Notice of Intent

Sundry ID: 2754851

Type of Action: APD Change

Procedure Description: Mewbourne Oil Company request a variance to perform break testing and offline cementing on the following wells: Querecho 23/26 Fed Com 523H Querecho 23/26 Fed Com 616H Night Watch 2/1 Fed Com 511H Night Watch 2/1 Fed Com 513H Gemini 36/35 Fed Com 513H Gemini 36/35 Fed Com 516H Corona 25/26 Fed Com 525H Corona 25/26 Fed Com 528H Pavo Macho 31/33 Fed Com 616H Pavo Macho 31/33 Fed Com 618H

Figure 1. Cactus 13 3/8" 5M offline cementing tool. Pressure rating limited by the lesser of 5M tool rating or the 13 3/8" pup joint and casing.

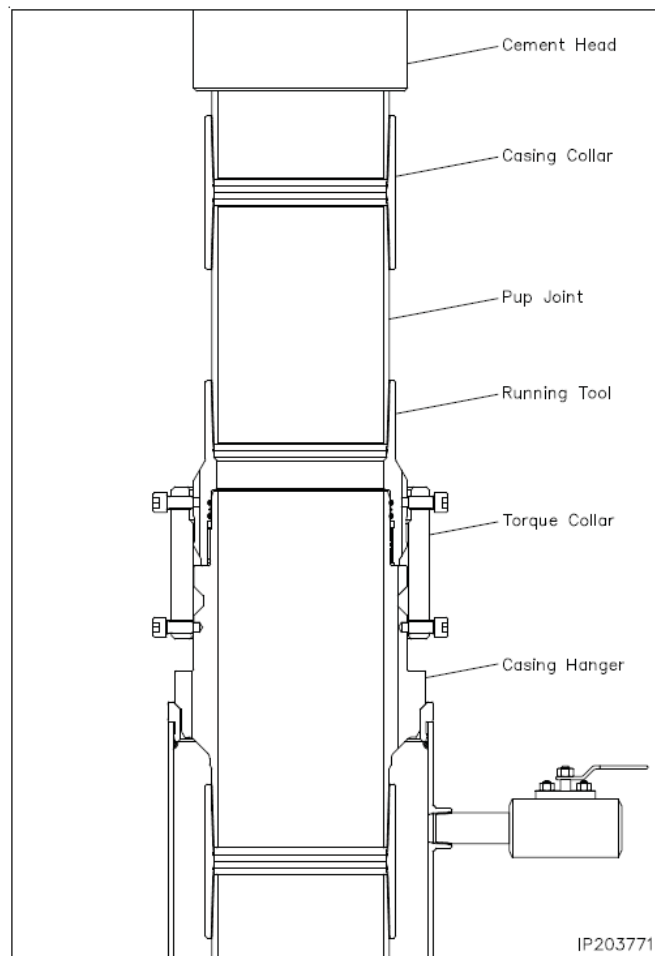
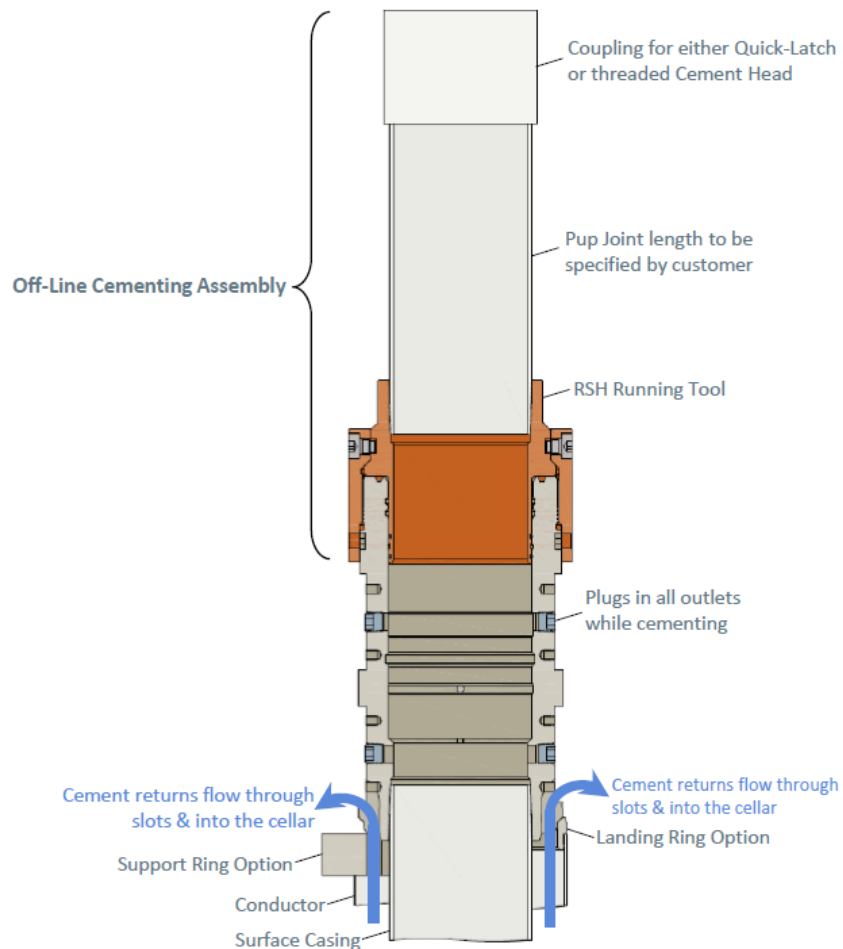
9. Make up offline cement tool with forklift per wellhead manufacturer (Fig. 1 & 2).
10. Make up cement head on top of offline cement tool with forklift.

Offline cementing variance is approved for surface and intermediate casings only. Contact the BLM prior to the commencement of any offline cementing procedure.

Figure 3. Cactus 9 5/8" 5M offline cementing tool. Pressure rating limited by the lesser of 5M tool rating or the 9 5/8" pup joint and casing.

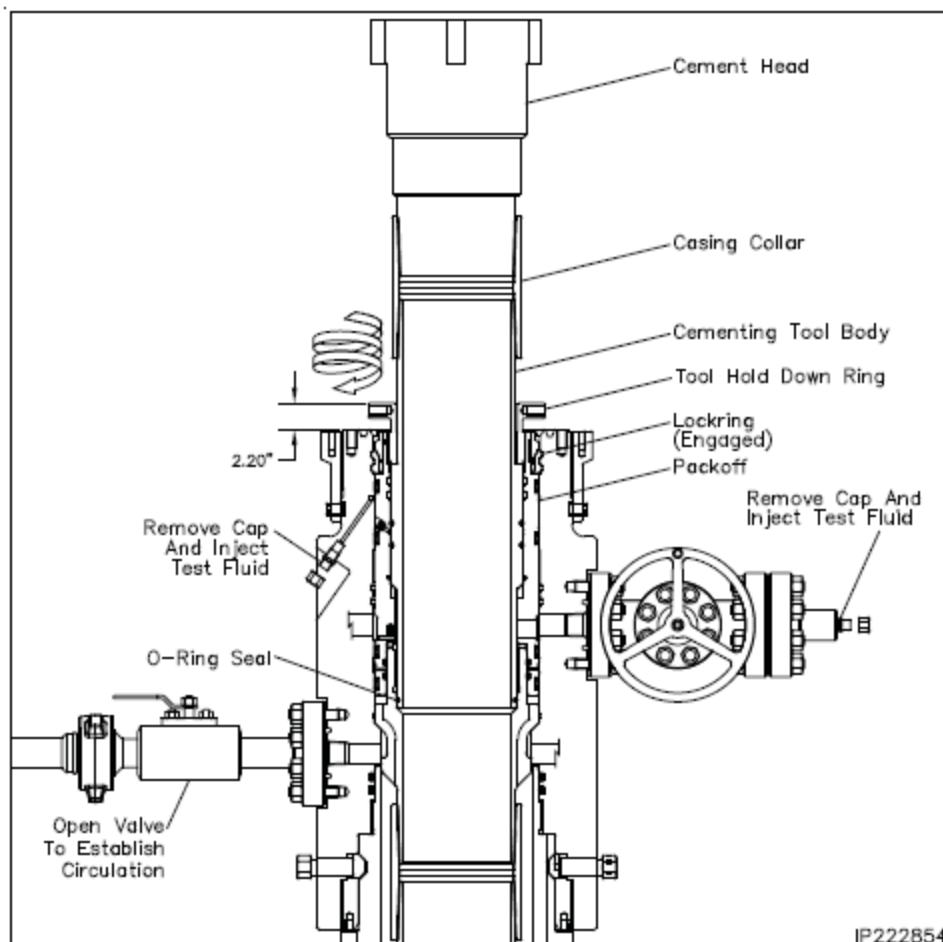
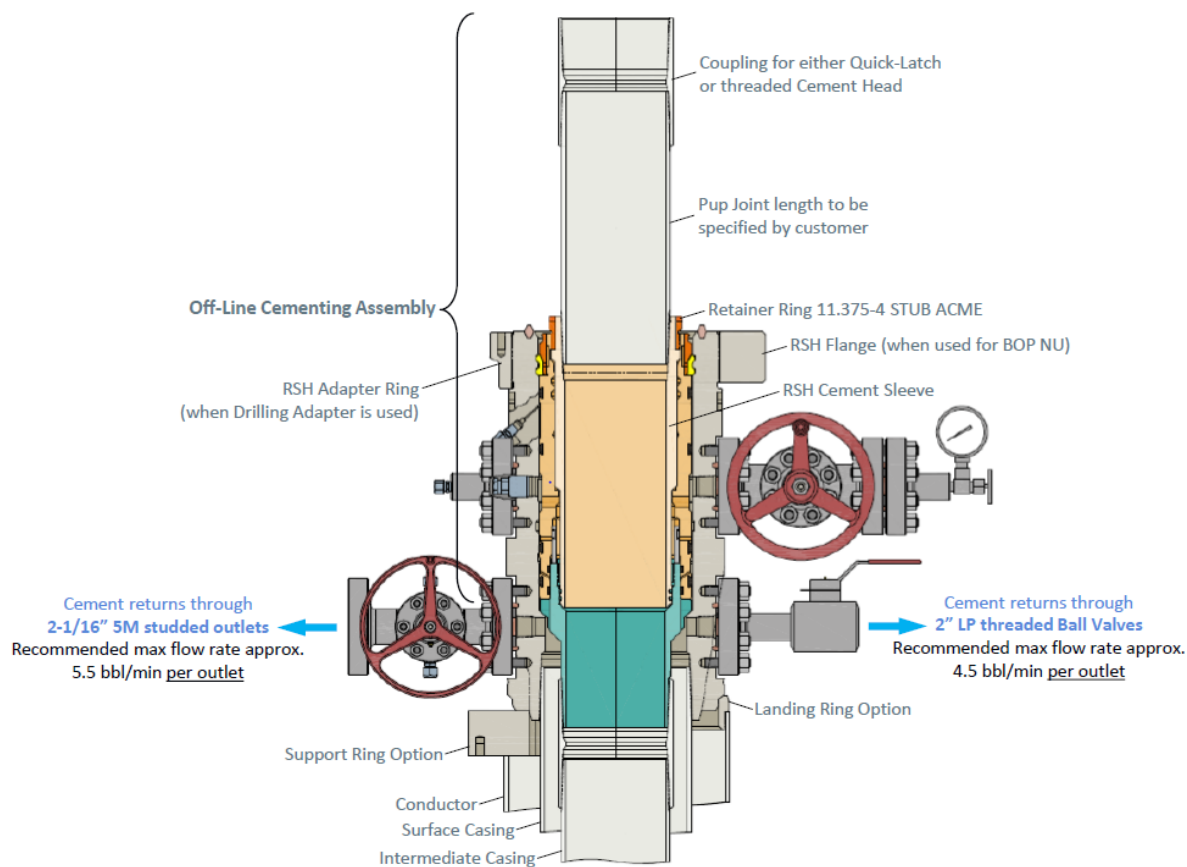
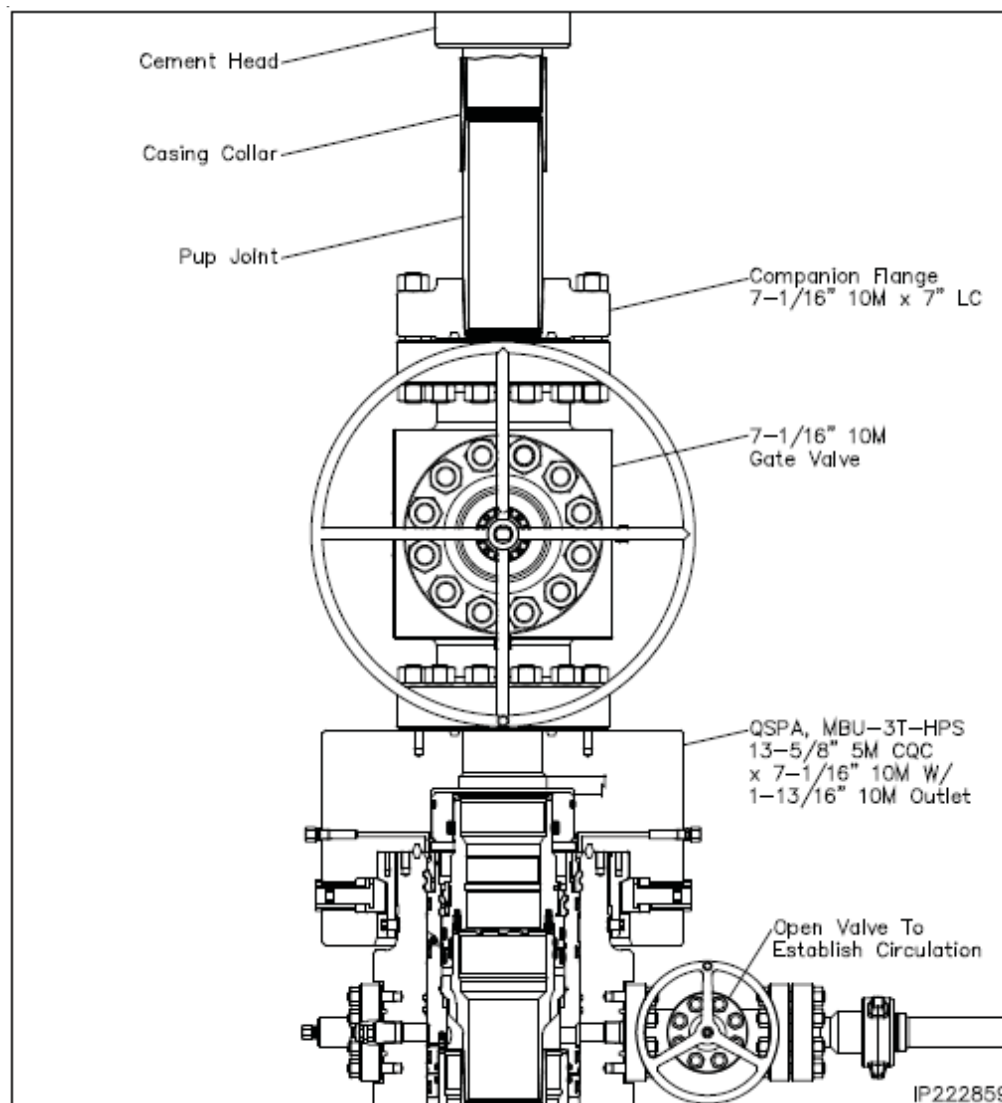
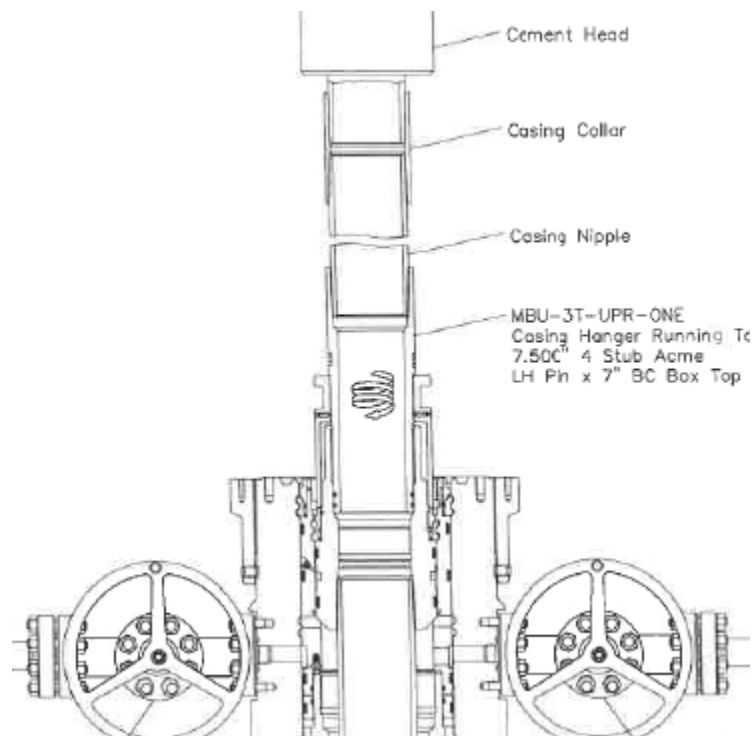
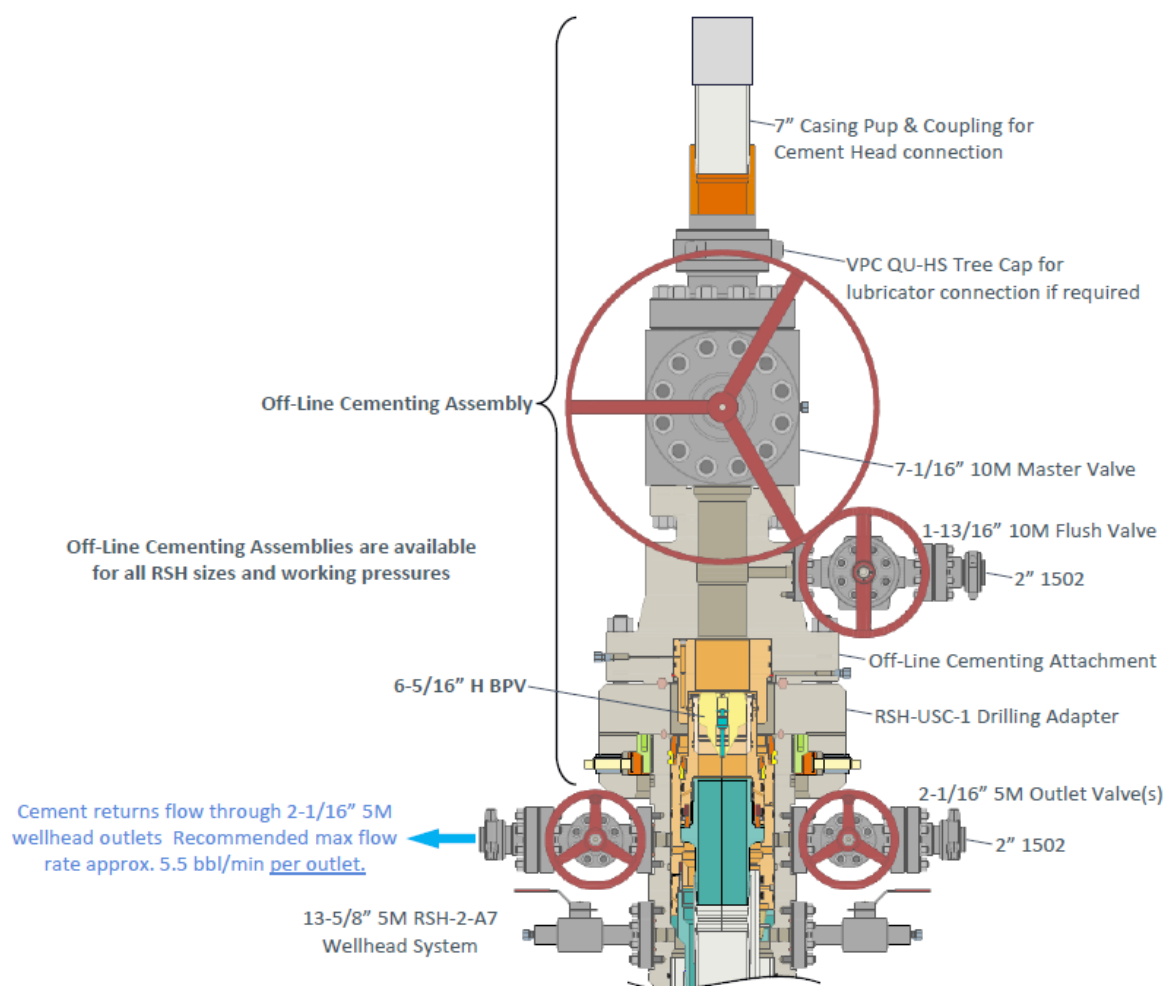
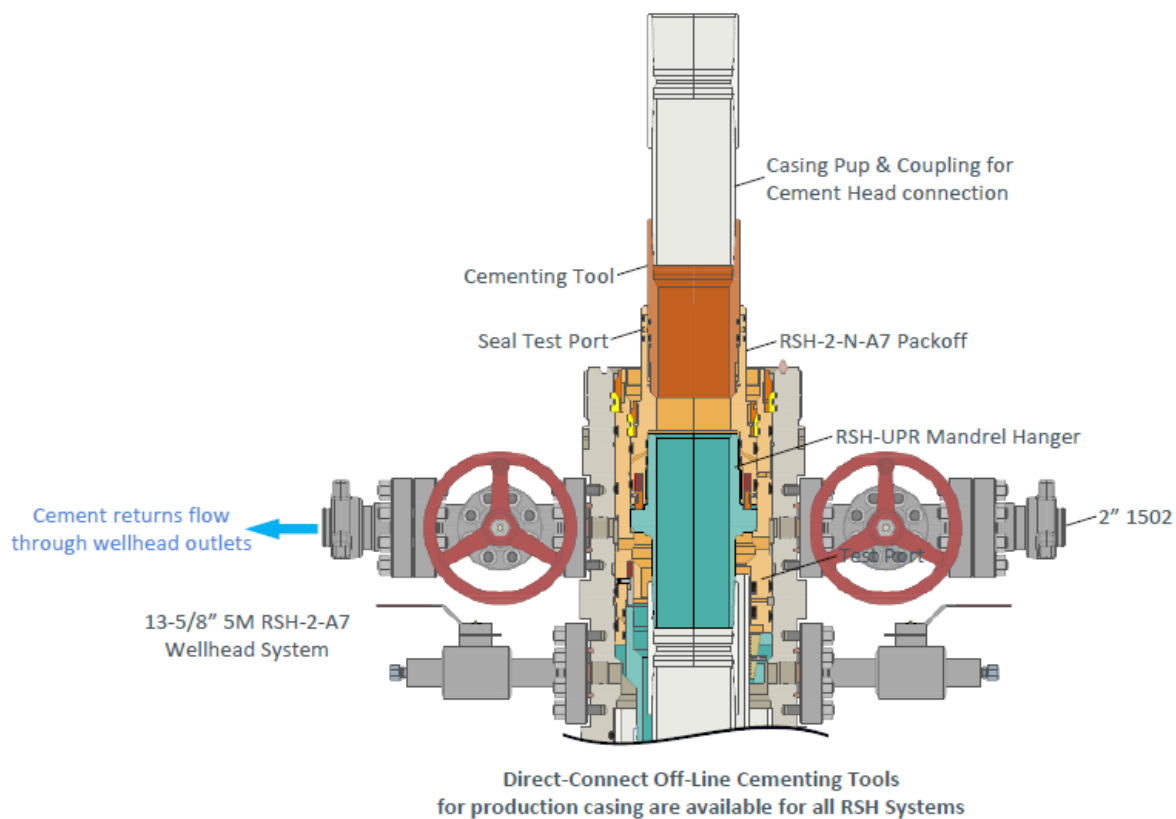
10. Make up offline cement tool using forklift per wellhead manufacturer (Fig. 3 - 8).
11. Make up cement head on top of offline cement tool.
12. Commence cement operations.

Figure 1. BOP diagram

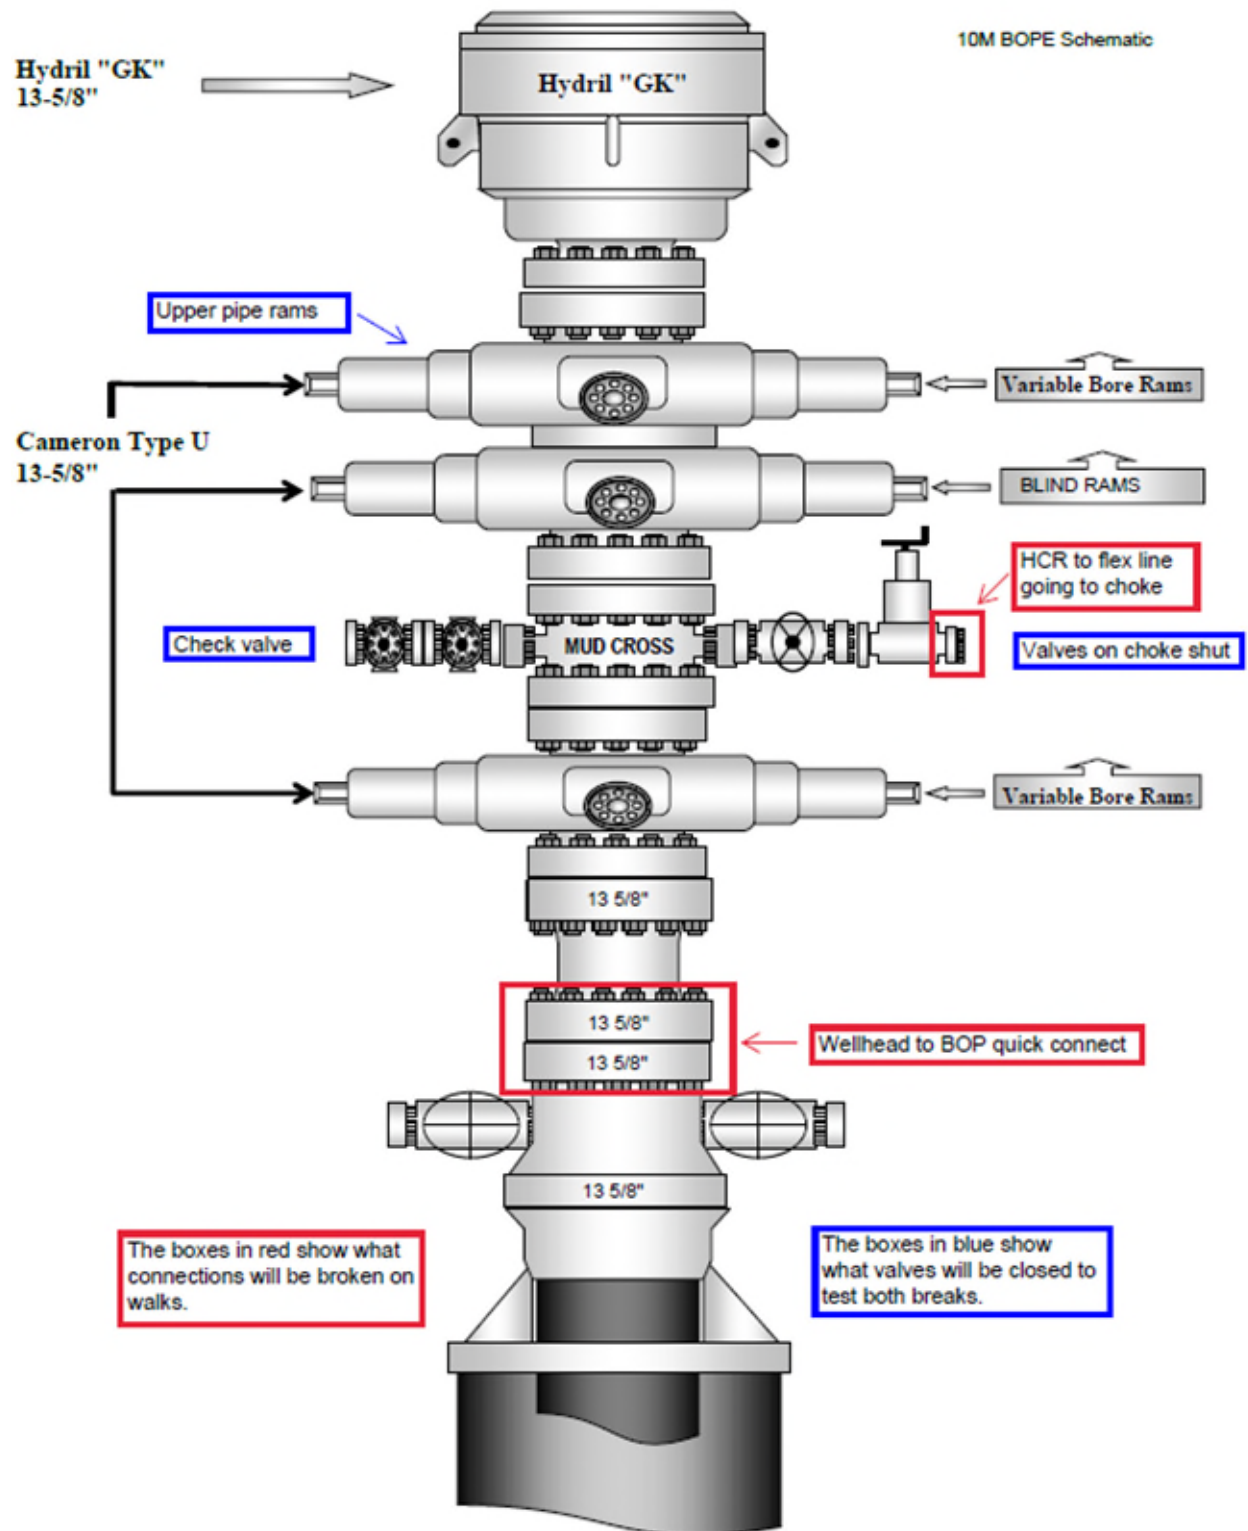
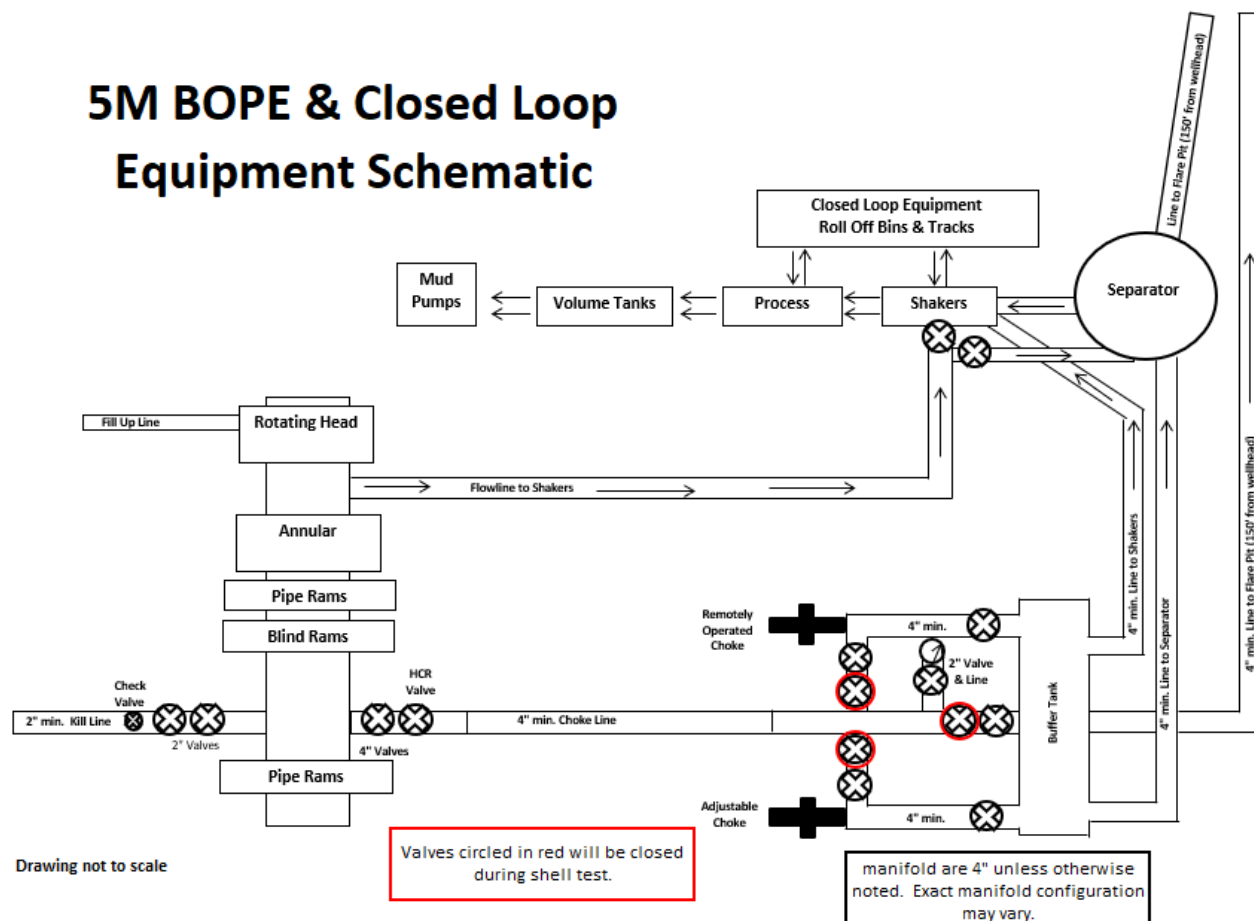
2. After the well section is secured and the well is confirmed to be static, the BOP will be disconnected from the wellhead and walked with the rig to another well on the pad. Two breaks on the BOPE will be made (Fig. 1).

9. A test will then be conducted against the upper pipe rams and choke, testing both breaks (Fig. 1 & 2).
10. The test will be held at 250 psi low and to the high value submitted in the APD, not to exceed 5000 psi.

- BOPE Break Testing is ONLY permitted for 5M BOPE or less. **(Annular preventer must be tested to a minimum of 70% of BOPE working pressure and shall be higher than the MASP)**

Figure 3. BOP handling system

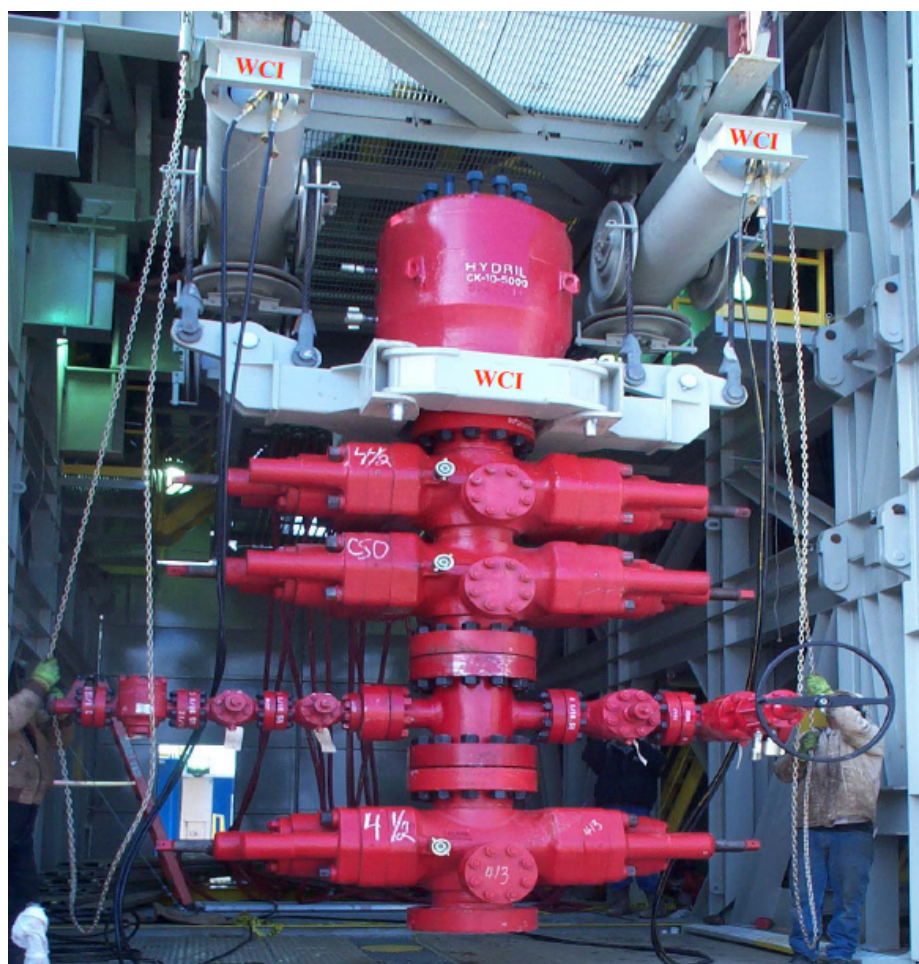
4. The BOP will be removed and carried by a hydraulic carrier (Fig. 3 & 4).
5. The rig will then walk to the next well.
6. Confirm that the well is static and remove the capping flange.

- While in transfer between wells, the BOPE shall be secured by the hydraulic carrier or cradle.
- Any well control event while drilling require notification to the BLM Petroleum Engineer **(575-706-2779)** prior to the commencement of any BOPE Break Testing operations.
